**APPENDIX C7**  
**COMMENTS RECEIVED**

**BASIC ASSESSMENT AND PUBLIC PARTICIPATION PROCESS FOR HIGHVELD SOLAR PV FACILITY AND ASSOCIATED GRID CONNECTION SOLUTION NEAR STILFONTEIN – NORTH WEST PROVINCE**

# Google\_SE3330 Highveld Solar PV Facility

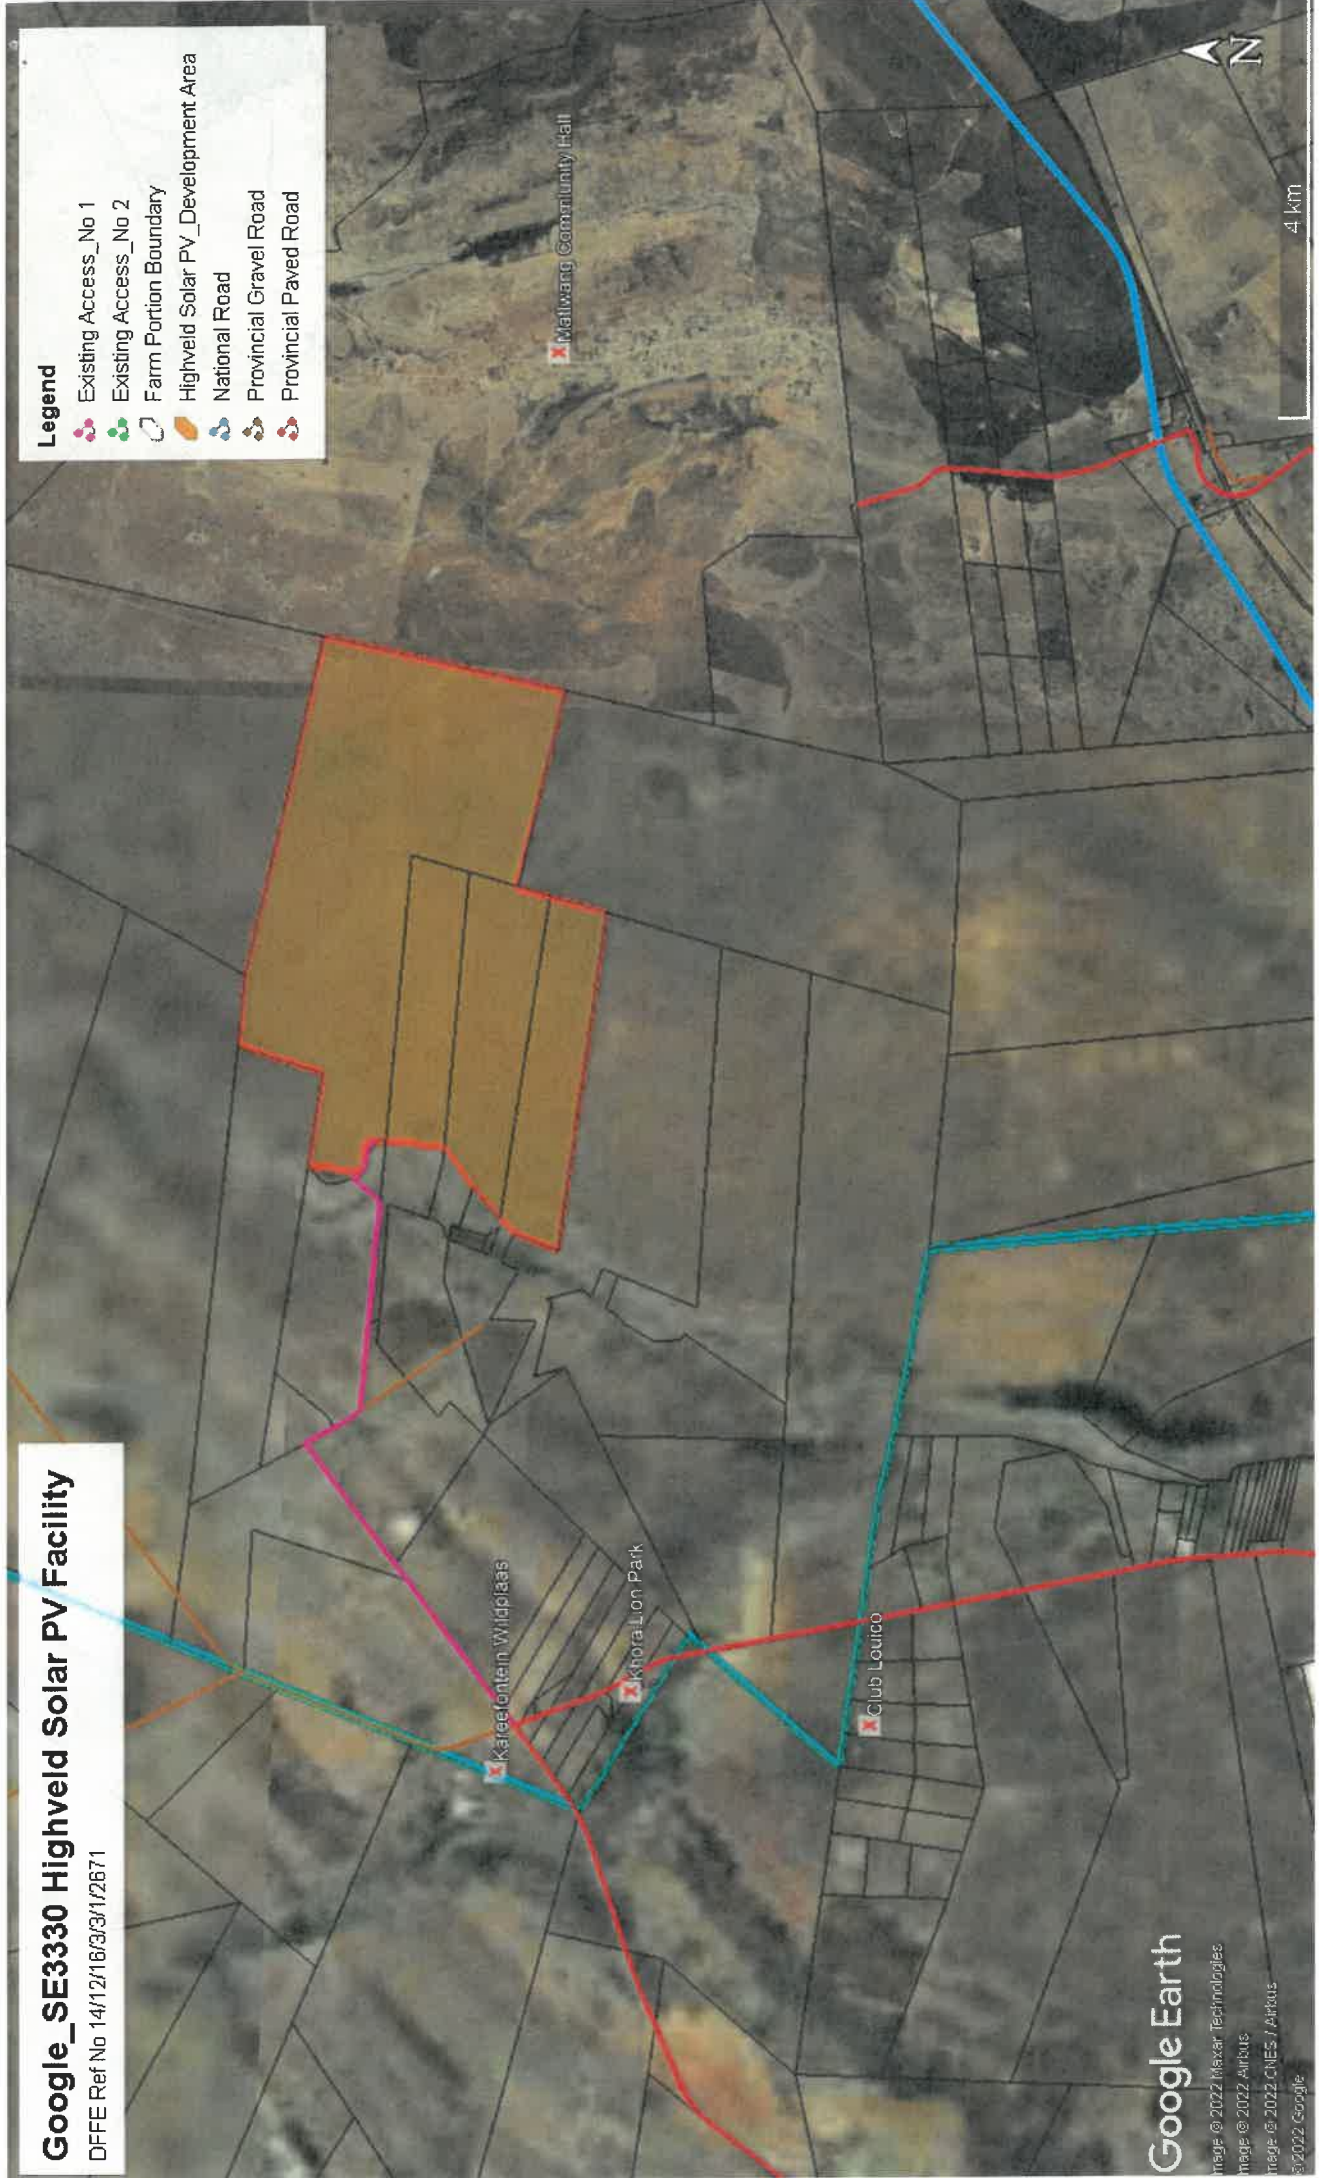
**2.1** The proposed development will utilize an **existing Gravel access(es)** which will connect and or intersect with the Provincial Gravel Road D586 may be used for the operational purposes as a **permanent access** to the **Proposed Development** as illustrated on the following Layout Drawings No./ Locality Maps: -

- a) **Google\_SE3330 Highveld Solar PV Facility**
- b) **Locality Map\_SE3330 Highveld Solar PV Facility**
